PRE- 2003-083

## **General Meeting Notes – G½ & 26 Rd. (SW corner)**

# Review Agency Comment Sheet

File Name: C:\projects\2082\2082prelim.dwg			
<b>STARLIGHT RIDGE FORMAL PRE-APPLICATION SUBMITTAL SUBVISION SKETCH</b>			
Designed RLR	Checked TDR	Proj# 2082	Sheet 2
Drawn RLR	Date 5/1/03	Rv.	Of 11

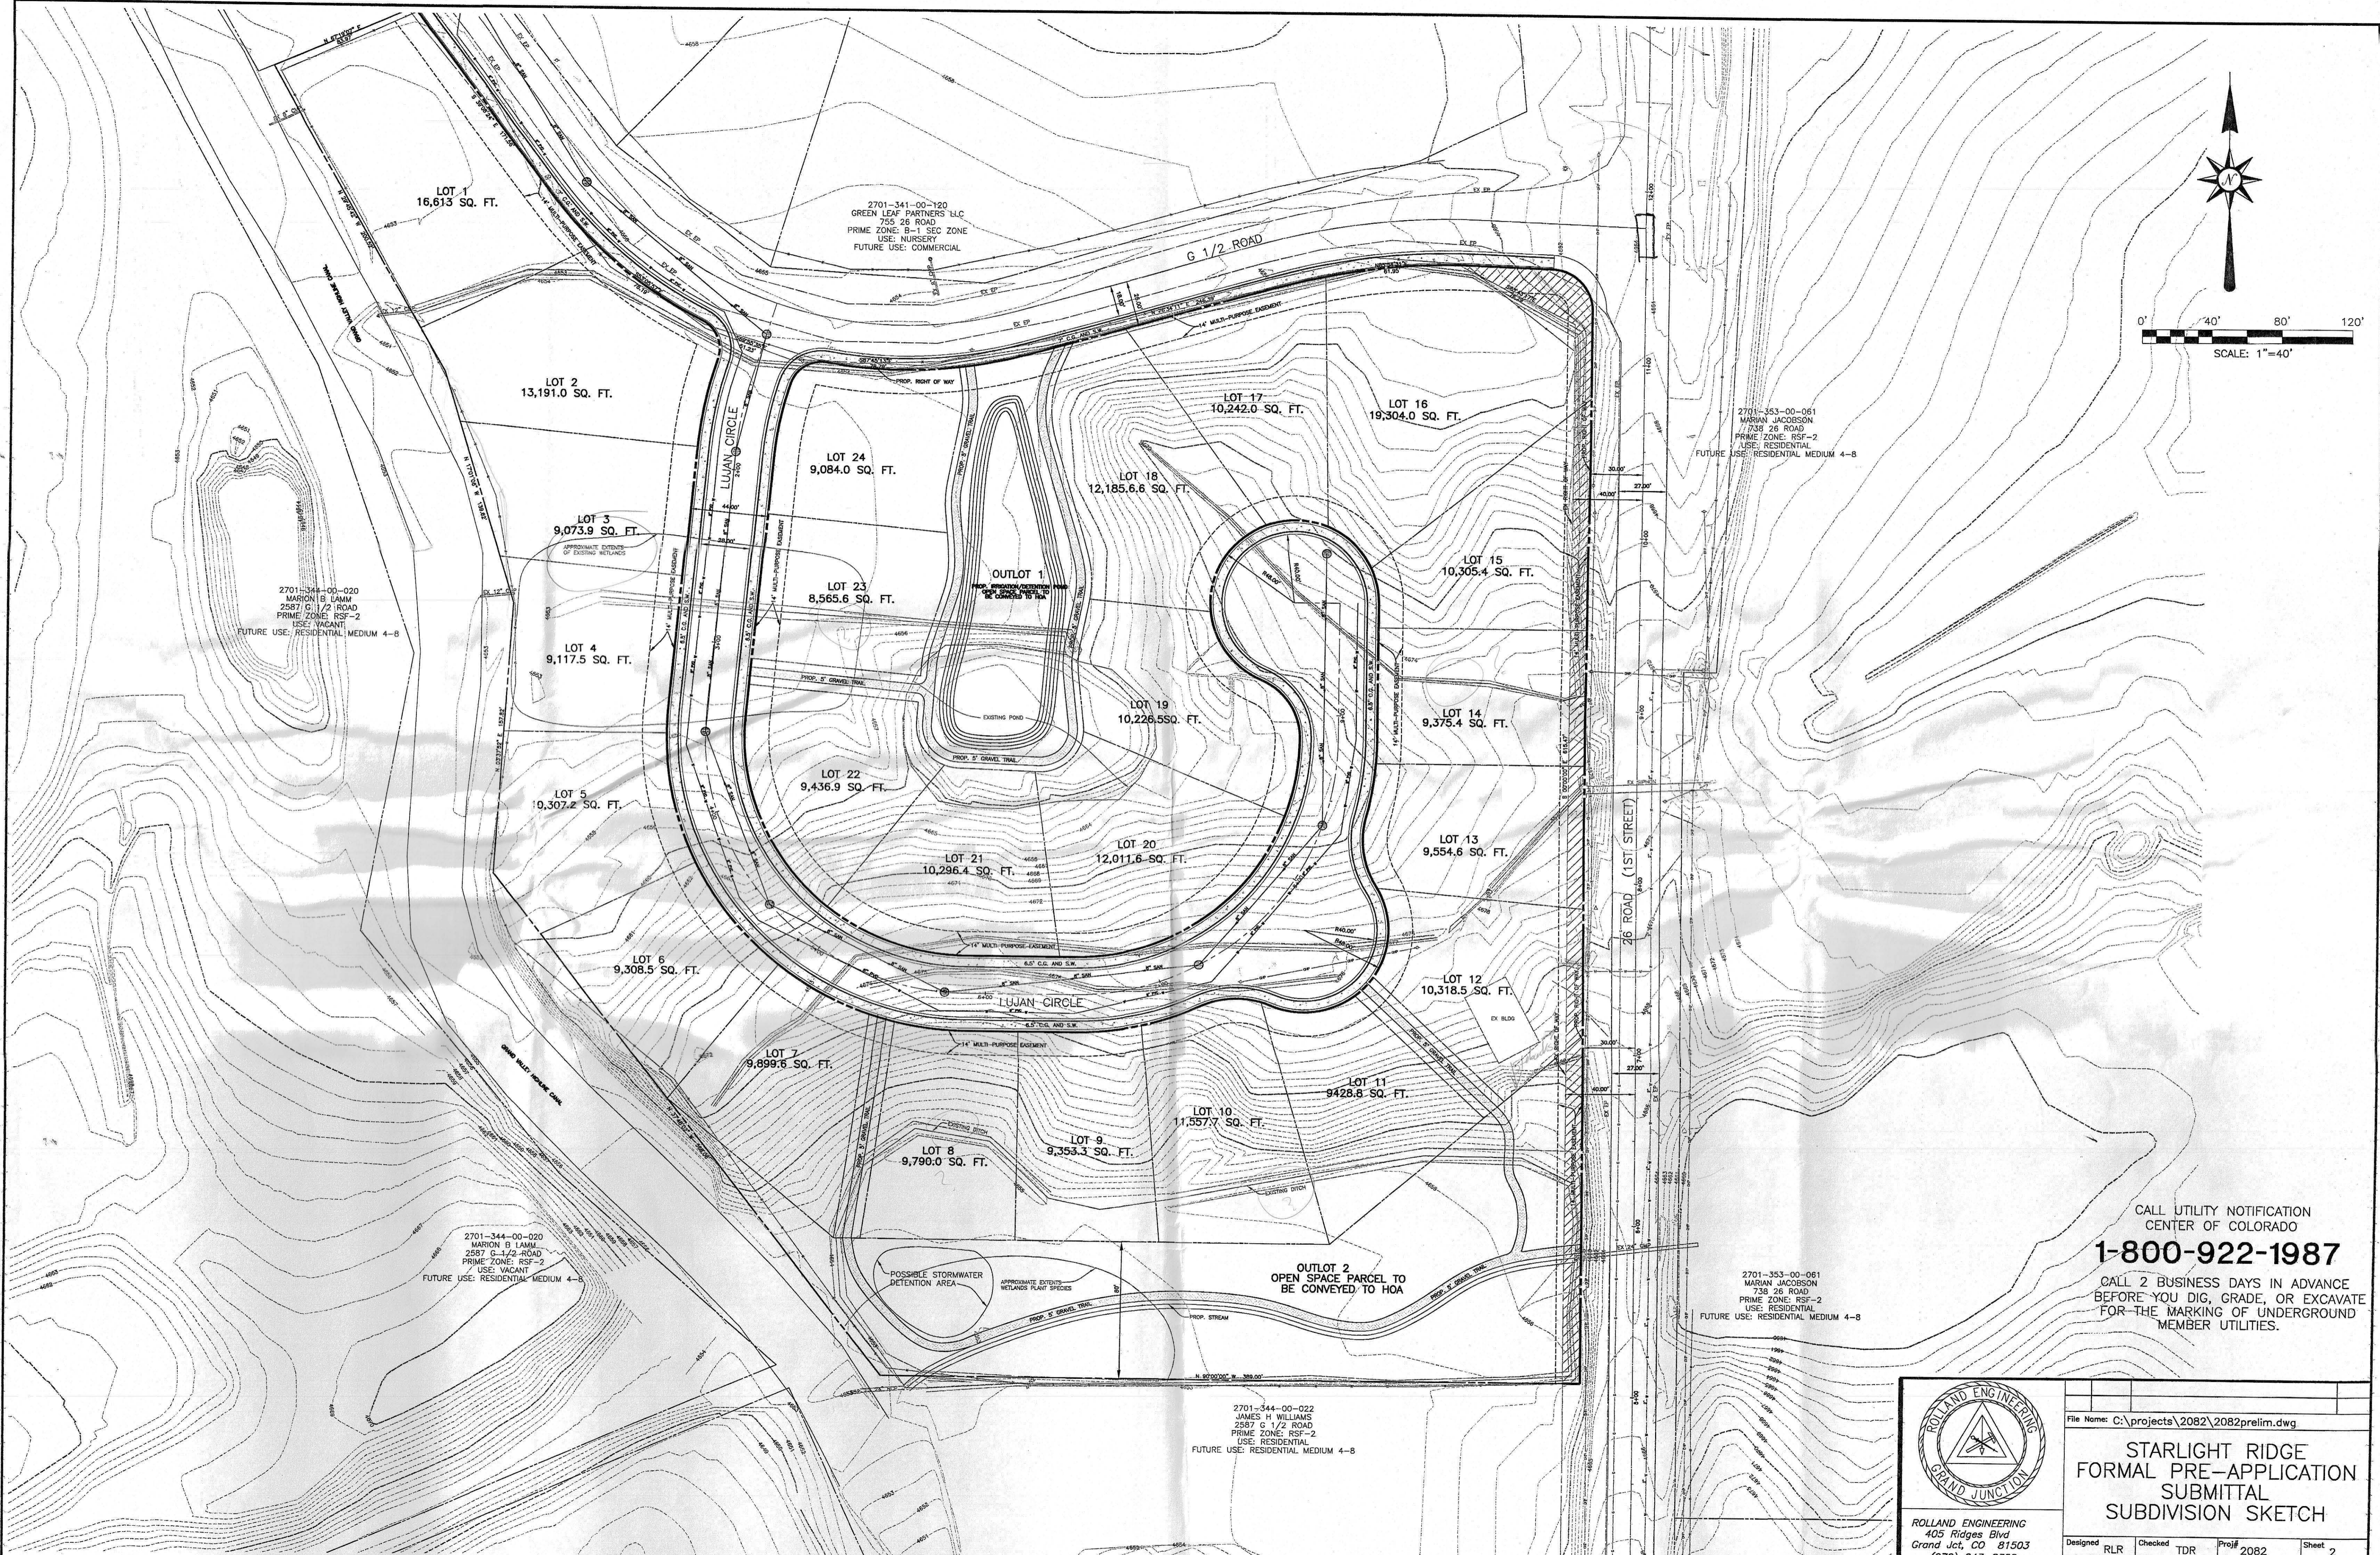
- From an Engineering perspective, four-plexes could be allowed to access G ½ Road; however, it is doubtful that the lots shown can provide the proper parking and site layout requirements.
- The stub street to the south needs to be provided unless you can demonstrate a substantial reason why one shouldn't be provided in which case a TEDS exception will be necessary.
- The City will want to contract with you to design and build the 26 Road improvements as part of this project. Consequently, the profile of 26 road and the schedule would be driven by this project and City requirements.
- Theoretically another street intersection could happen nearer 26 Road provided it meets the intersection spacing criteria in TEDS. We would however prefer not to have it. Particularly since the street stub to the south meets the second access requirements.

10. The gravel trails that pass between the lots on the south edge of the parcel appear to be extremely steep.
11. The results of the wetlands study must be submitted at Preliminary Plan and incorporated in the drawings.

2. The Fire Department supports street connections between developable parcels in order to improve emergency response options to a given location and also to provide residents of an area at least two choices to exit back to a main public street. A street stub to the south would allow future connection to 2587 G 1/2 Road should that property be subdivided and developed in the future.

STARLIGHT RIDGE  
FORMAL PRE-APPLICATION  
SUBMITTAL  
26 ROAD PLAN & PROFILE

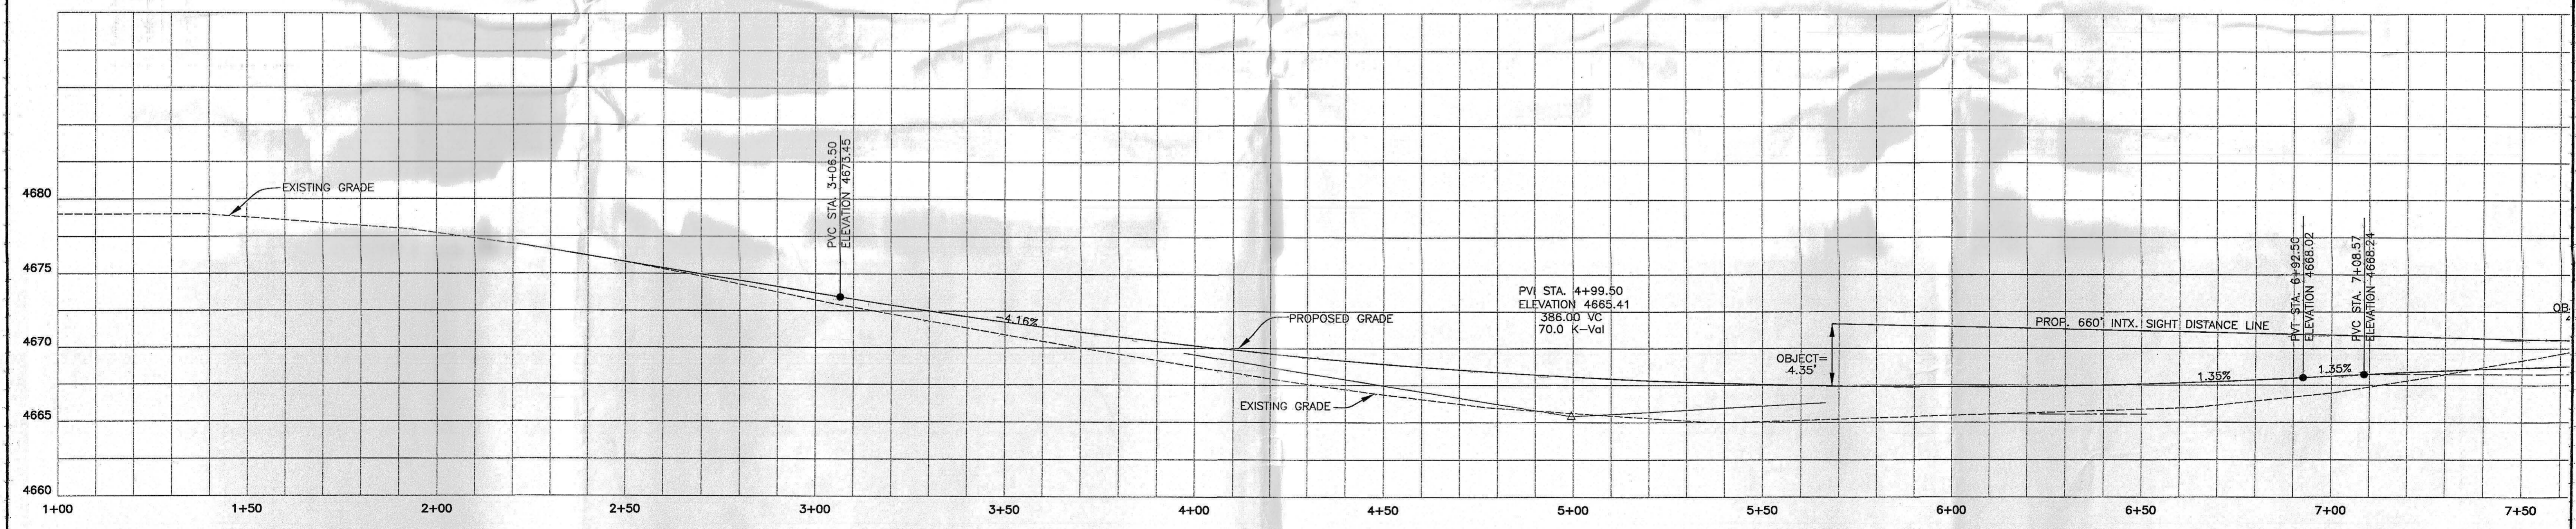
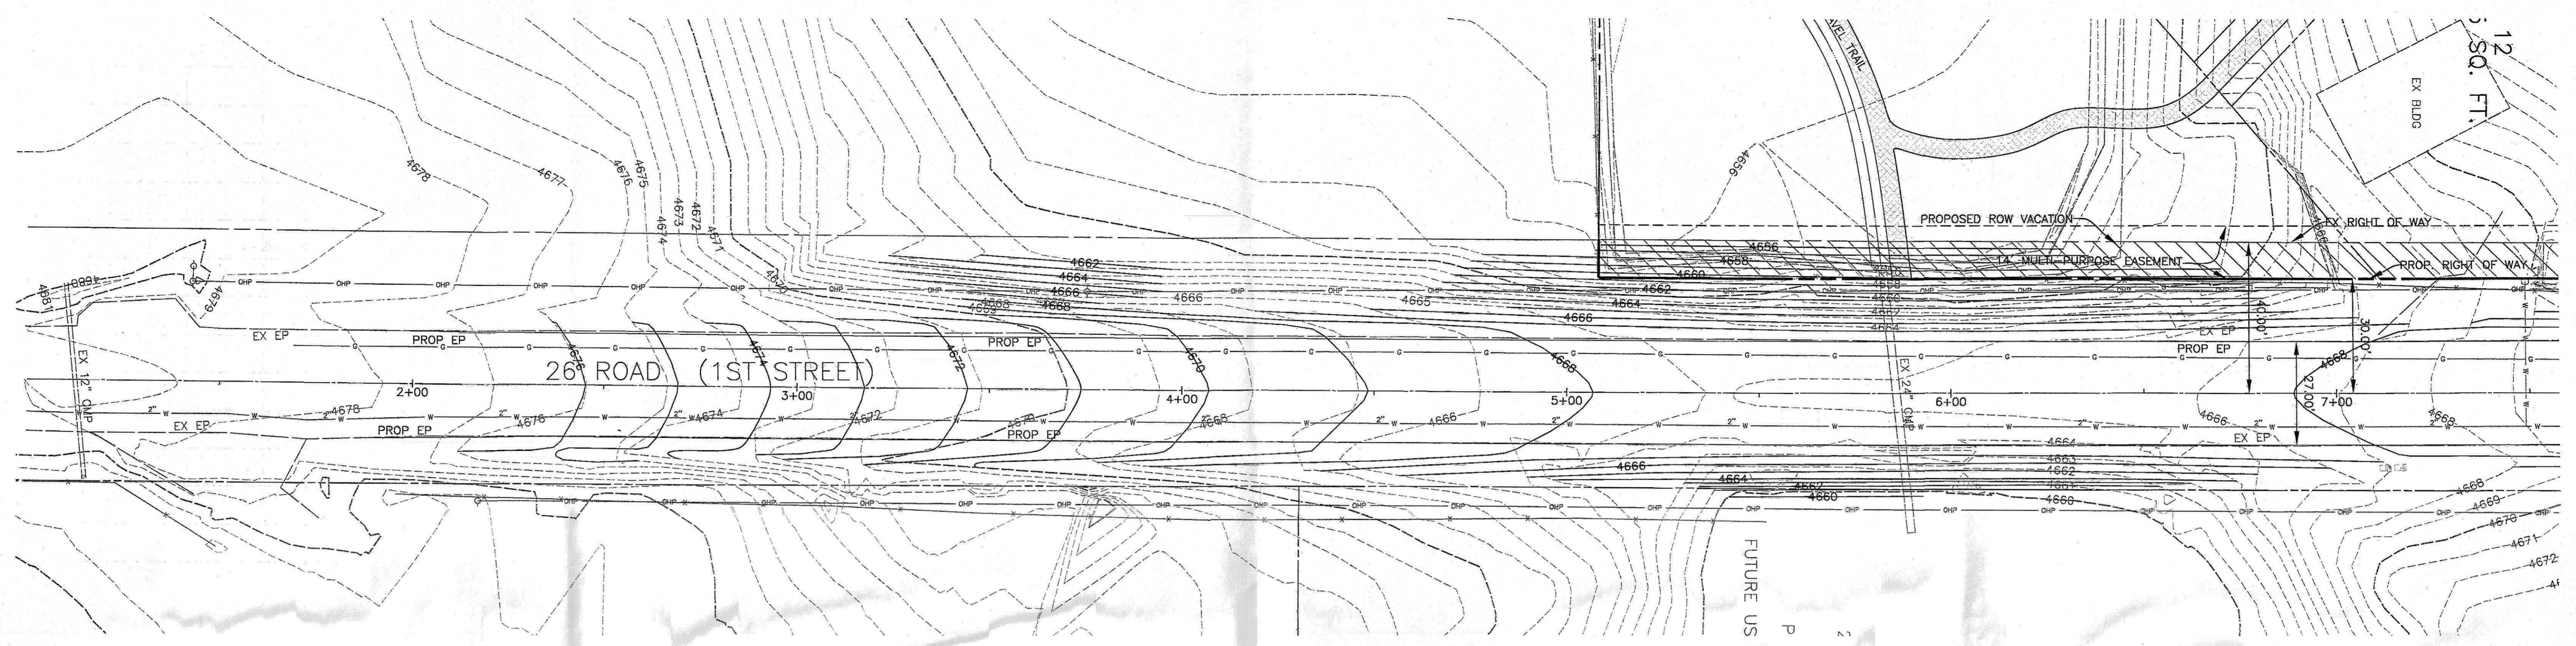
1. Modify the vertical alignment of the road to meet TEDS, eliminating stopping sight distance and intersection sight distance problems due to the current "dipsy-do" alignment.
2. Provide a left-turn lane on 26 Road to facilitate north-bound traffic turning west onto G-1/2 Road.
3. Provide curb, gutter & walk along the project's 26 Road frontage.

My reasoning behind this prioritization goes something like this: unless the sight distance problems are fixed, the left-turn lane will not operate very efficiently, and fixing the sight distance problems will make the left turn movements at G-1/2 Road less problematic (even though it doesn't eliminate the possibility that the left-turn lane is warranted due to turning volumes). For these reasons, I place higher priority to fixing the sight distance problems. The curb, gutter and walk are the lowest priority because they don't provide any sort of mitigation to the existing safety problems (sight distance and turn lane need). They are important however, because they provide a starting point for the discussion regarding the developer's responsibilities. The curb, gutter and walk improvements represent the very minimum equivalent value that the City should accept.
